SSES-FSAR

QUESTION 312.1

FIGURE 312.12-1, Rev 47
 AutoCAD: Figure Fsar 312_12_1.dwg

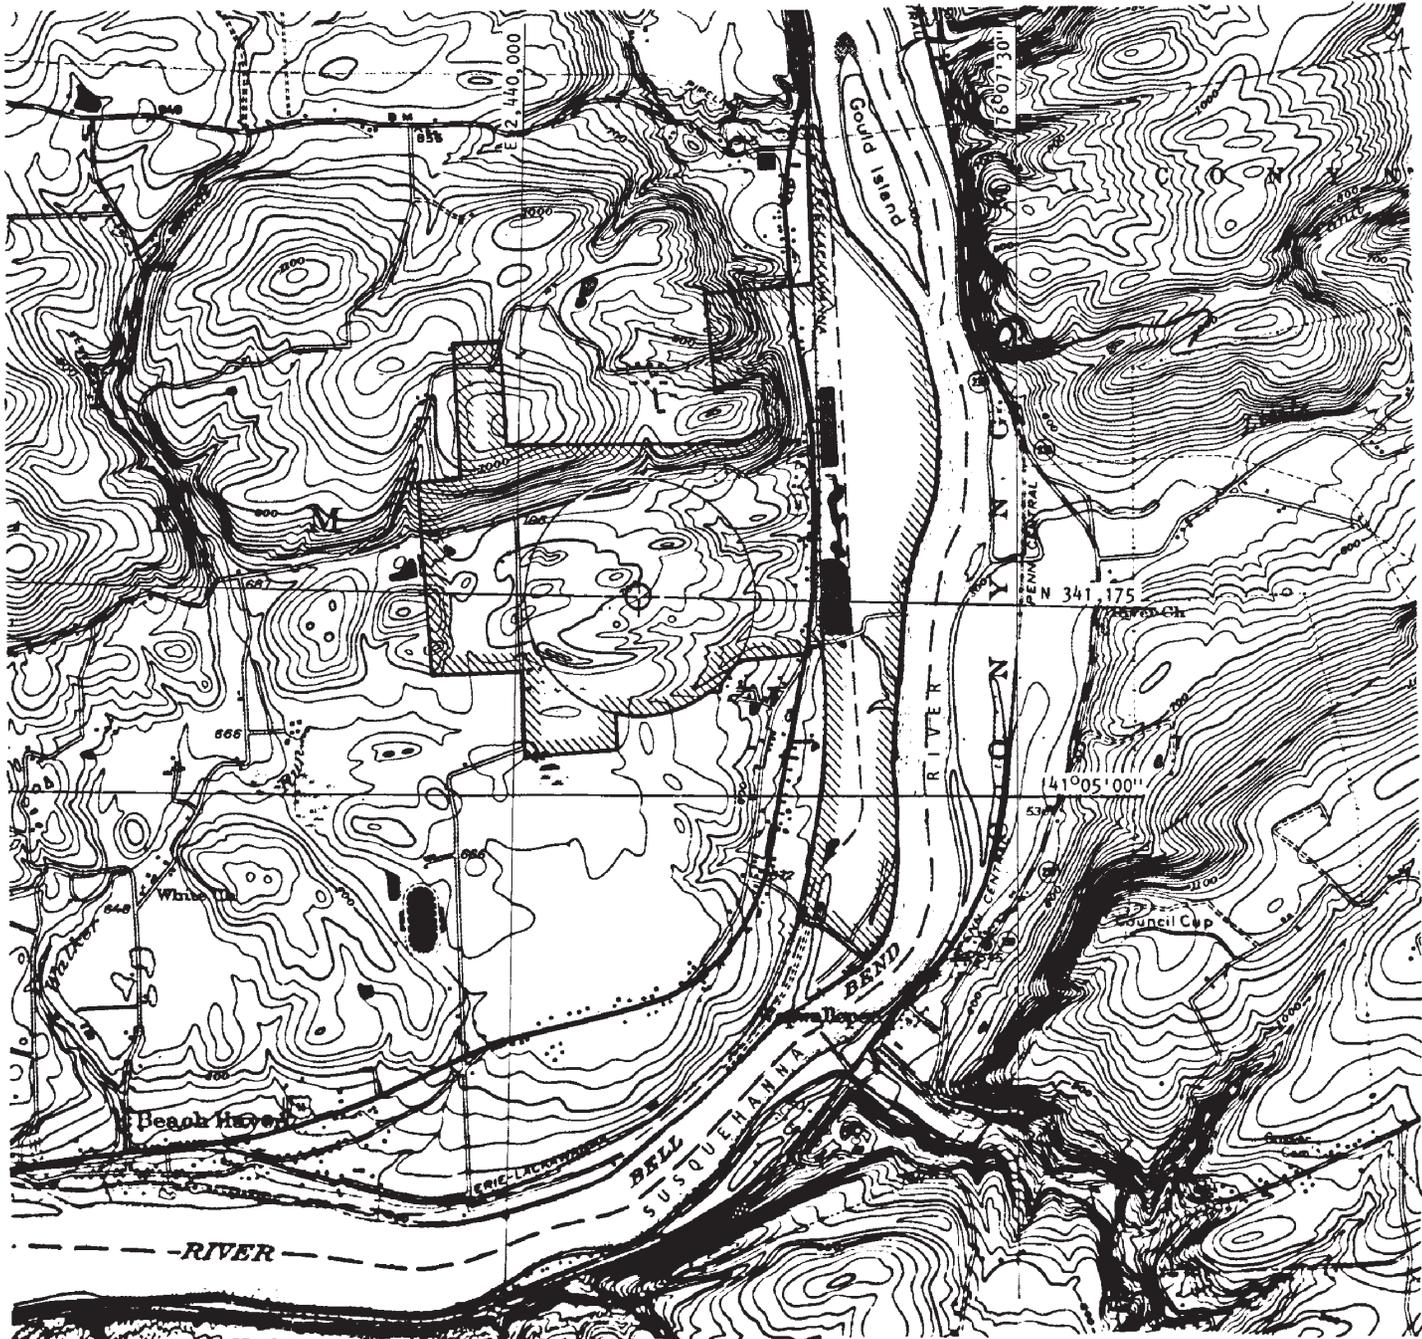
None of the maps in the FSAR clearly show the exclusion area boundary. Provide a full scale section of the USGS map of the Berwick, PA quadrangle which clearly shows the exclusion area as well as the plant boundary. (FSAR Figure 2.1-1 is too small to provide sufficient detail.)

RESPONSE:

See the SSES Emergency Plan or the Technical Specifications for a depiction of the exclusion area.
